<b>SERVICE</b> 		<b>9</b>
		<b>X 89.119-26</b>

**MODELS 281, 288**

**A NEW CHAIN BRAKE WITH KNEE LINK FUNCTION**

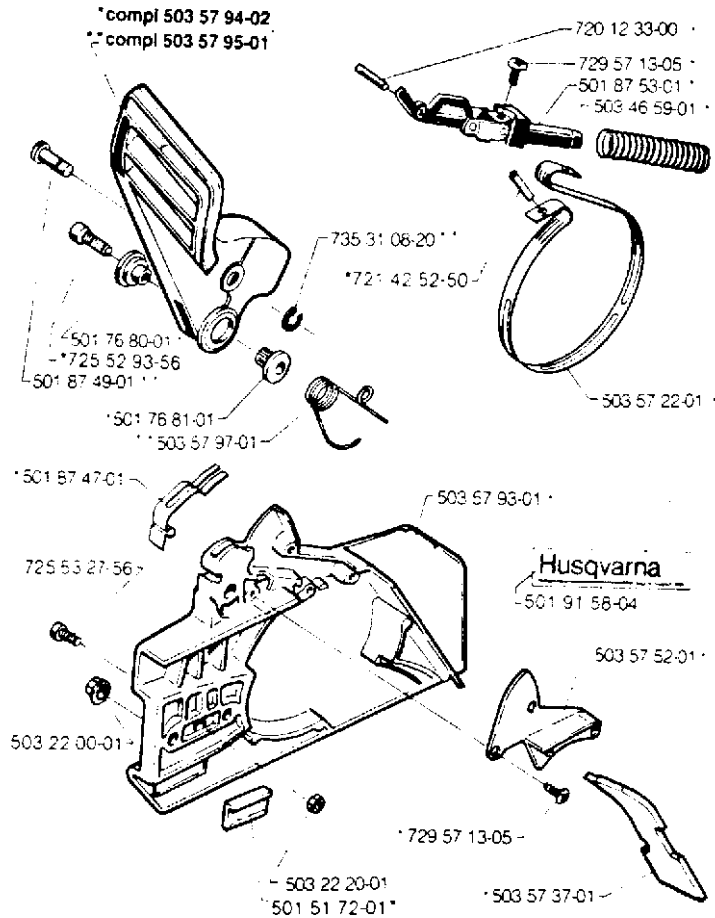
A new type of inertia activated chain brake with knee link function is introduced on the models above, The chain brake is the same design as the ones on the models 40/45, 242 and 254.

The new chain brake is introduced from serial number 281 -9260401  
288-9270400

When the new chain brake is introduced, a new silencer and spike are introduced at the same time. The new chain brake can only be mounted on saws equipped with the new silencer with a so called spark arrestor and with the new spikes.

On saws with lower serial number than 281-9160025, 288-9110080, the guide must be cut off before the chain brake can be mounted, according to the illustration. This is made because there is no guide bushing in the crankcase.
